ADMINISTRATIVE CONTROLS

6.0 ADMINISTRATIVE CONTROLS

FIGURE 6.2.1-1 OFFSITE ORGANIZATION
DELETE

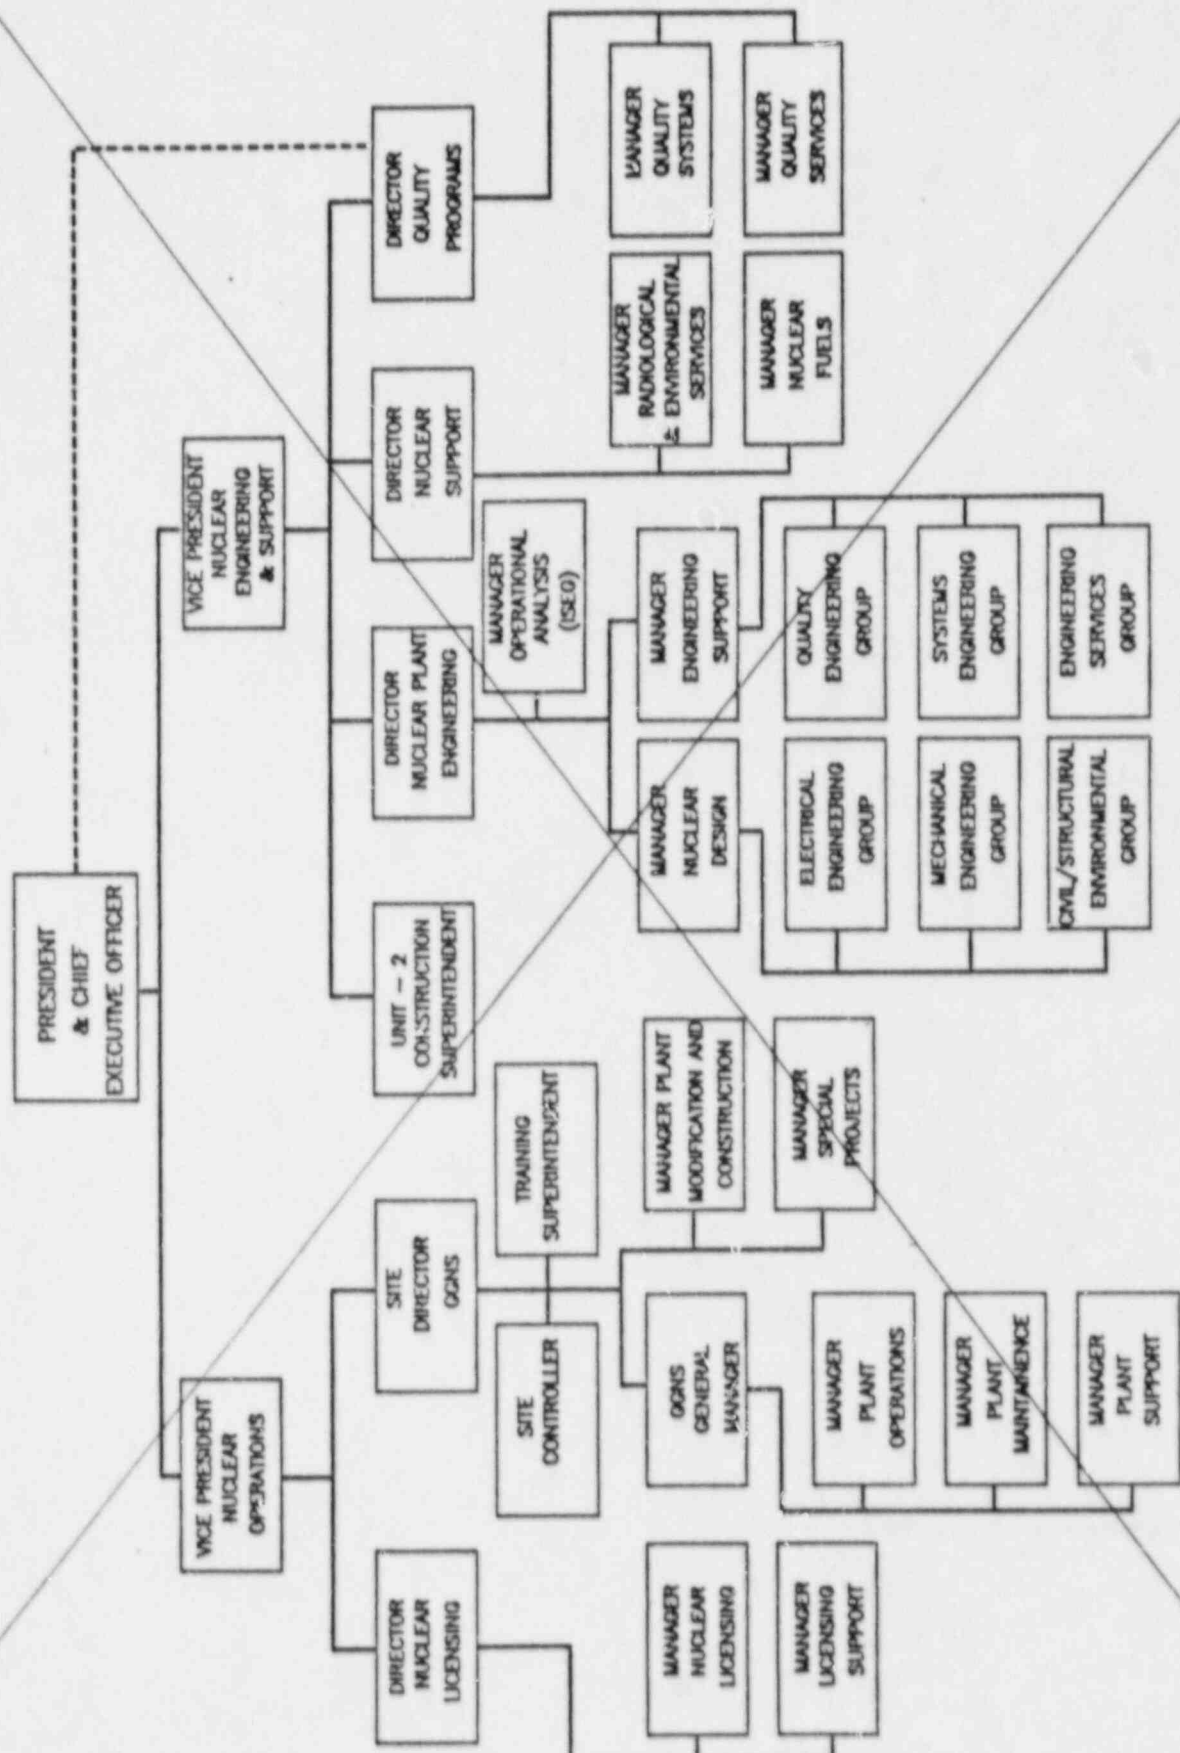
~~The offsite organization for unit management and technical support shall be as shown on Figure 6.2.1-1.~~

Insert 1 →

Onsite and offsite organizations shall be established for unit organization and corporate management, respectively. The onsite and offsite organizations shall include the positions for activities affecting the safety of the nuclear power plant.

- a. Lines of authority, responsibility, and communication shall be established and defined for the highest management levels through intermediate levels to and including all operating organization positions. These relationships shall be documented and updated, as appropriate, in the form of organization charts, functional descriptions of departmental responsibilities and relationships, and job descriptions for key personnel positions, or in equivalent forms of documentation. These requirements shall be documented in the UFSAR and updated in accordance with 10CFR50.71(e).

FIGURE 6.2.2-1 UNIT ORGANIZATION

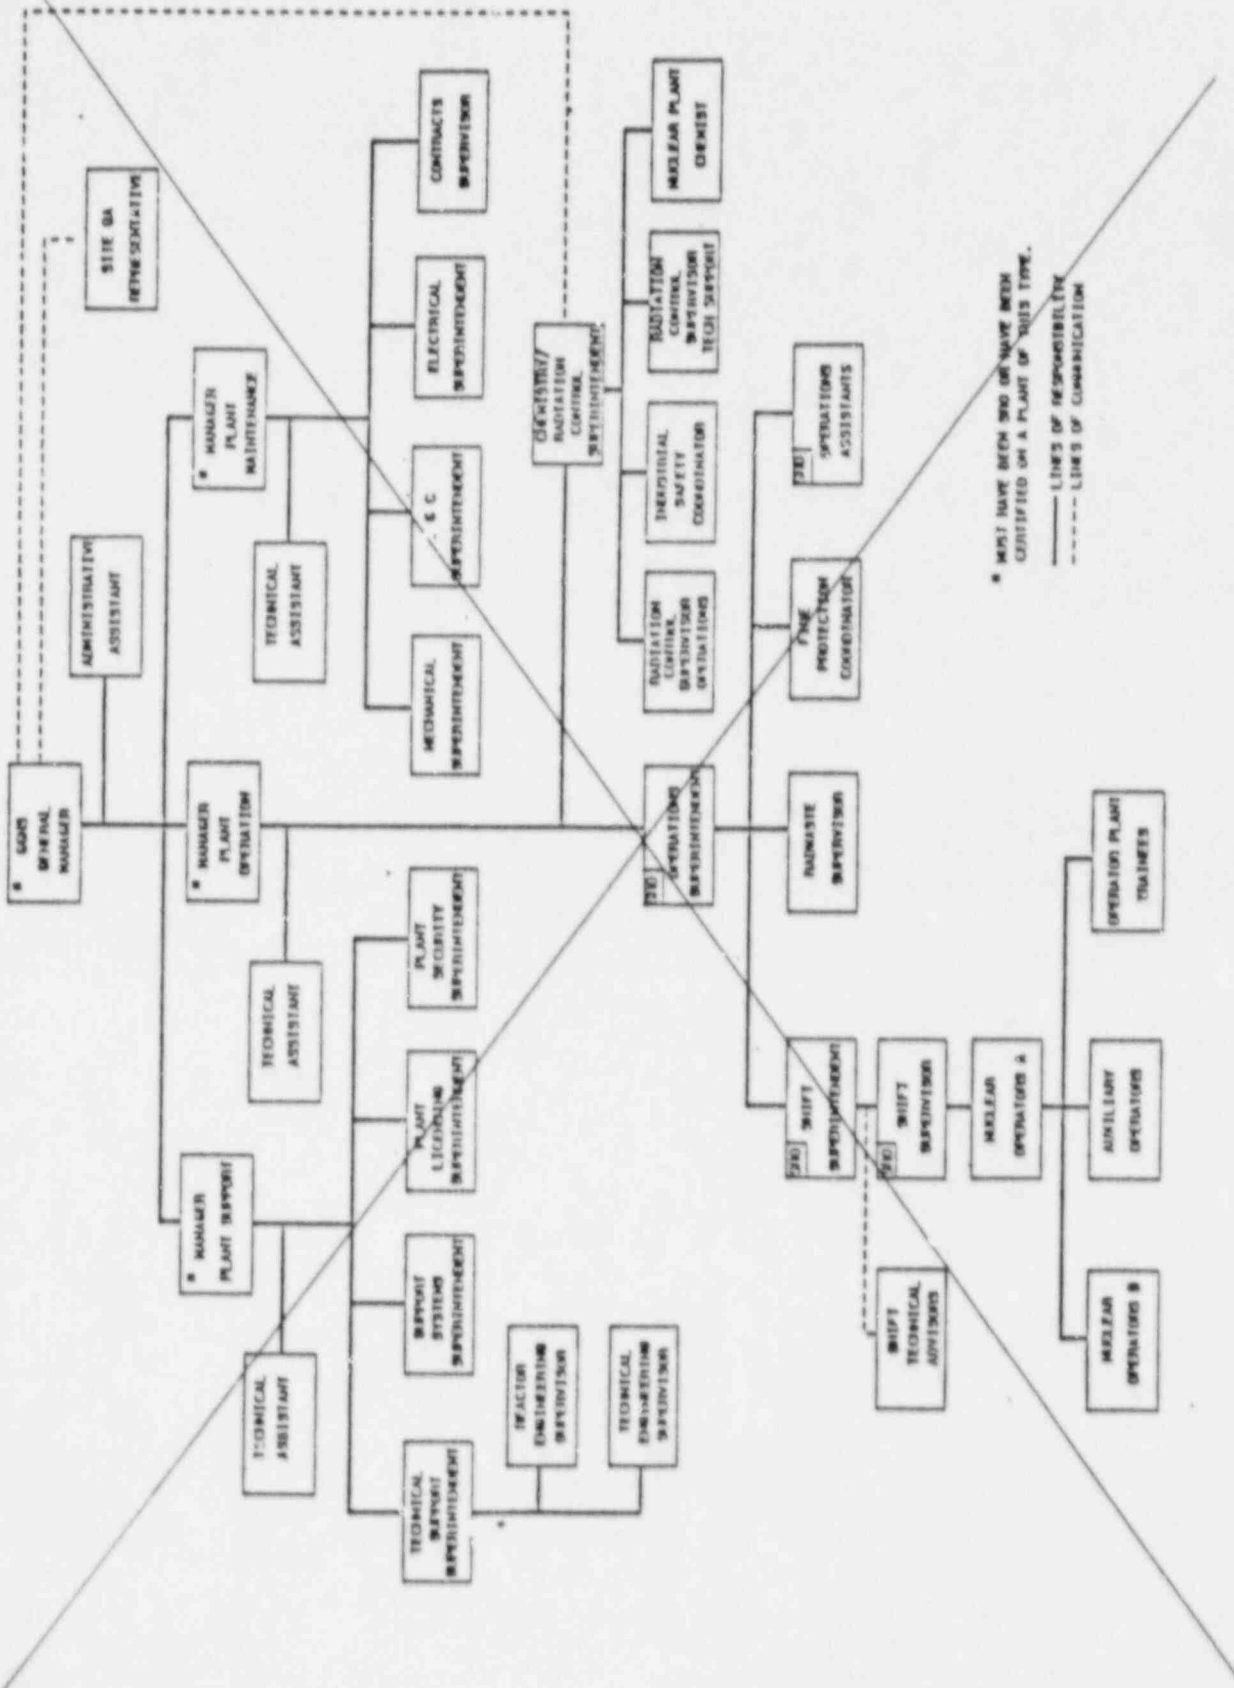
The unit organization shall be ^{subject to the following:} ~~as shown on Figure 6.2.2-1 and:~~

DELETE
